### STAFF RECOMMENDATION 4412 Elkins Avenue May 17, 2017

**Application:** New construction – addition and outbuilding; Setback determination

**Description of Project:** The applicant proposes to construct a rear addition and detached garage. A side setback determination for the garage would be required.

ELEVATIONS

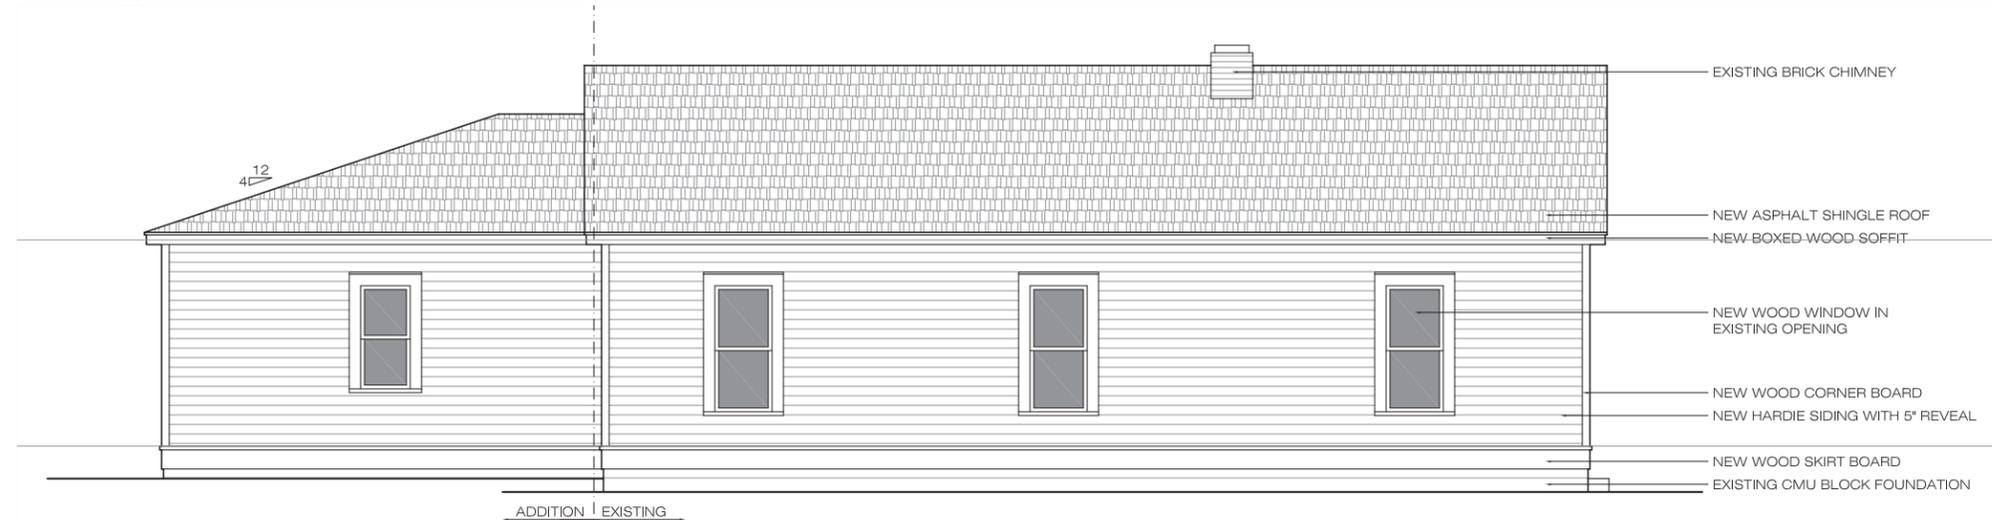
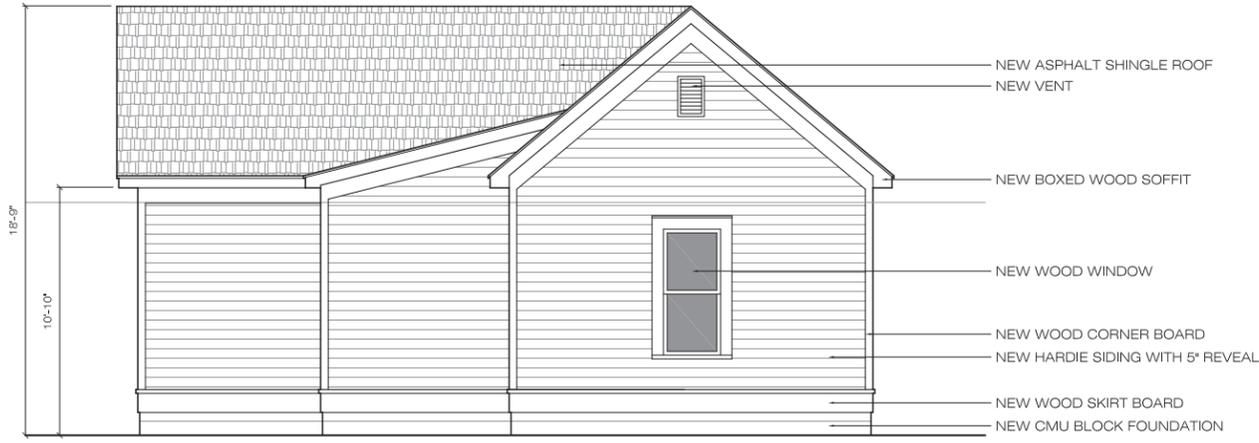
The existing front door is a sliding door, which is not original; and is proposed to be replaced with a pair of French doors matching the size of the existing opening. French doors, or double doors in general, are not typical of this type of building. Staff recommends that the door is replaced with a single half-light or full-light door.

The plans also show that the front porch roof will be changed from a shed to hipped. There is not clear physical or photographic evidence that shows the porch roof to have had a different shape, but the Sanborn map does suggest that the porch size has been modified. A hipped roof is not uncommon for porches on houses of this type, therefore staff finds that this alteration would not appropriate.

Height & Scale: The side walls of the addition will be stepped in one foot (1') from the walls of the existing house. The roof of the addition will meet the rear wall of the house two feet (2') below the existing roof, and the eaves will align with the existing eaves. The addition will add nineteen feet (19') of depth to the house, less than half of the depth of the existing house. Staff finds the proposed addition to meets sections II.B.1.a and II.B.1.b of the design guidelines.

Roof form: The roof of the addition will tie into the back of the existing house with a ridge two feet (2’) below the peak of the existing roof, extending out with a hipped form at the rear. The slopes, eaves, and fascia on the front and sides of the existing building will not be altered. The pitch of the new roof will be 4:12, which is compatible with the pitch of the existing roof and is compatible with the roofs on historic buildings nearby. Staff finds that the project meets section II.B.1.e of the design guidelines.

- The original window and door casings shall be preserved; and
- The front door shall be replaced with a single half-light or full-light door; and
- The eave height on the outbuilding shall be to no higher than ten feet (10').

GARAGE PLAN  
AND ELEVATIONS

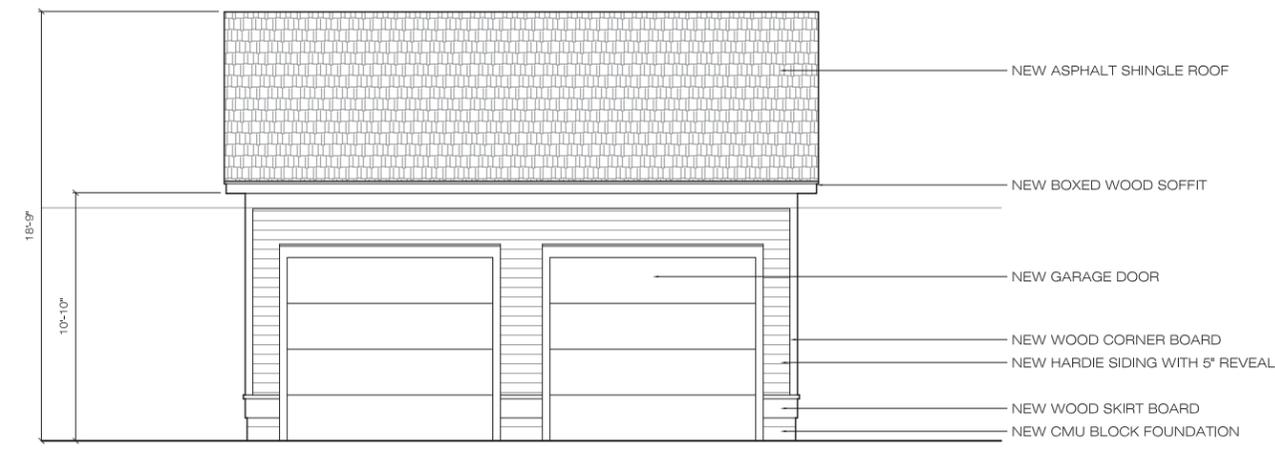
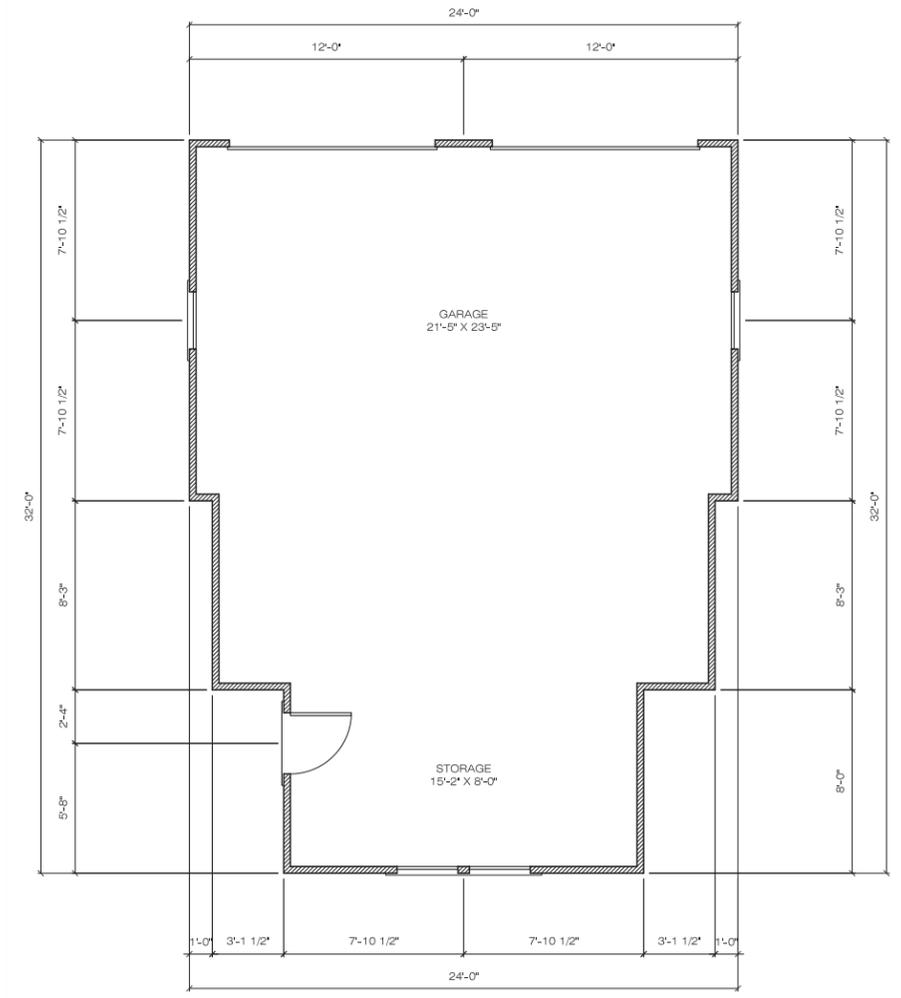
The building will be located at the rear of the lot, with garage doors facing 45<sup>th</sup> Avenue North. The proposed setbacks for the building are three feet (3') to the rear and four feet (4') to the sides. The standard street setback for a garage on a corner lot with garage doors facing the street is twenty feet (20'), however Staff finds the proposed setback to be appropriate because there is a thirty-five foot (35') unpaved buffer to the left of the property. This gives a perceived setback of nearly forty feet (40') from the street. Staff finds this to be compatible with the location of outbuildings historically. The rear and right side setbacks also meet the design guidelines and zoning requirements.

The roof and eave heights of the building match the principal building, however the guidelines limit the height of eaves on an outbuilding to ten feet (10'). With the condition that the eave height is no greater than ten feet (10'), Staff finds the height and scale of the proposed outbuilding would meet section III.B.1.i.1 of the design guidelines.

- The original window and door casings shall be preserved; and
- The front door shall be replaced with a single half-light or full-light door; and
- The eave height on the outbuilding shall be to no higher than ten feet (10').
